ENGINEERING BULLETIN

Subject: INSTINCT Solo DHW Setpoint Setting

Date: 11/13/19

DHW Setpoint Adjustment

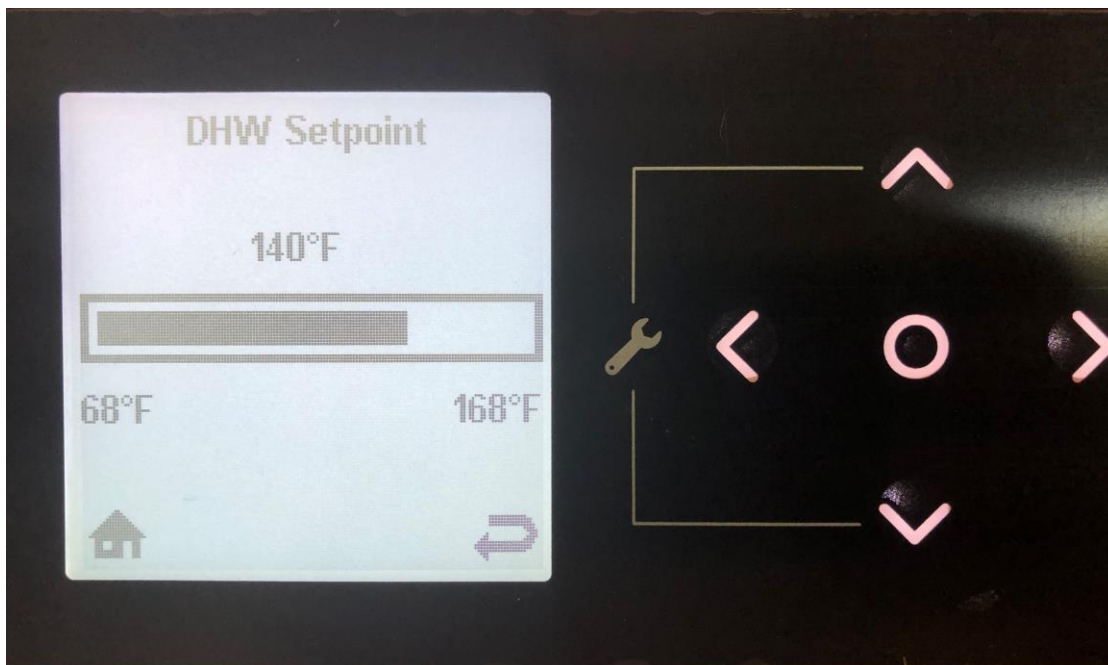
Initial shipments of INSTINCT Solo units display the DHW Setpoint setting in the Installer DHW menu but do not allow it to be adjusted. The DHW Setpoint setting can still be adjusted in the EZ Setup menu.

All INSTINCT Solo units shipped after 11/1/19 contain display software version 0.29 which allows DHW Setpoint to be adjusted in both EZ Setup and the Installer DHW menu.
